SERVICE BULLETIN

MODEL: WASHINGTON AND GRANT

COMPLAINT: Failure of TR-5 (P/N 2000-214) resulting in poor or

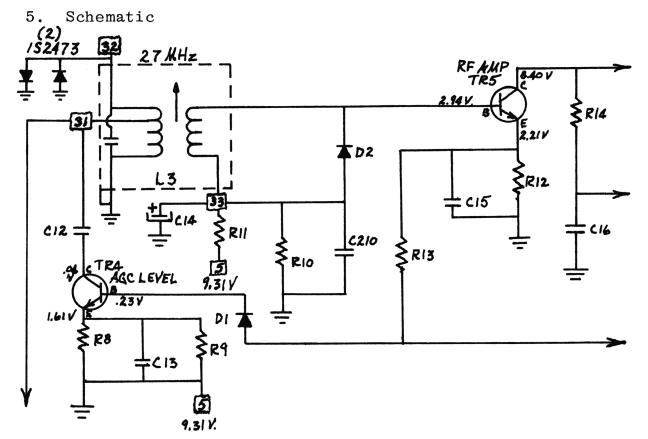
inoperative receiver.

1. Replace TR-5

- 2. Install a 10K ohm 1/4 or 1/2 watt resistor directly across the antenna connector (J401). Make certain good solder joints are made. Difficulty in heating the ground side may be encountered. Use minimum lead length.
- 3. Install a pair of back to back diodes directly across the primary of L3. Use P/N 2000-310 (1S2373) or equivalent. It is essential that minimum lead length be used on the diodes.
- 4. It will be necessary to realign L3 and L4 to obtain optimum performance. This should be done on channel 19 or 20.

6. Make certain the shielded lead connected to the antenna connector is dressed as far away as possible from TR-5.
